PLUG AND ABANDONMENT PROCEDURE

Jicarilla 28-02-09 #23

UNITED STATES DEPARTMENT OF THE INTERIOR BUREAU OF LAND MANAGEMENT FARMINGTON DISTRICT OFFICE

Re: Permanent Abandonment Well: 23 Jicarilla 28-02-09

Jicarilla 28-02-09 #23 Proposed P.&A

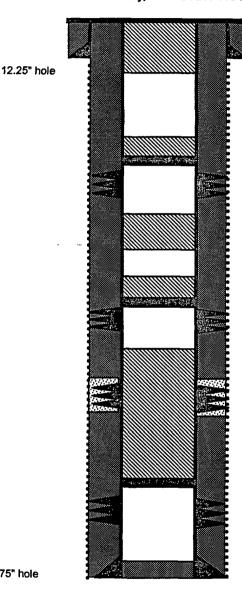
- 1. Plugging operations authorized are subject to the attached "General Requirements for Permanent Abandonment of Wells on Federal and Indian Lease."
- 2. Farmington Office is to be notified at least 24 hours before the plugging operations commence (505) 599-8907.
- 3. The following modifications to your plugging program are to be made:
- a) Place the Nacimiento plug from 2273' 2173'.

2273 2173
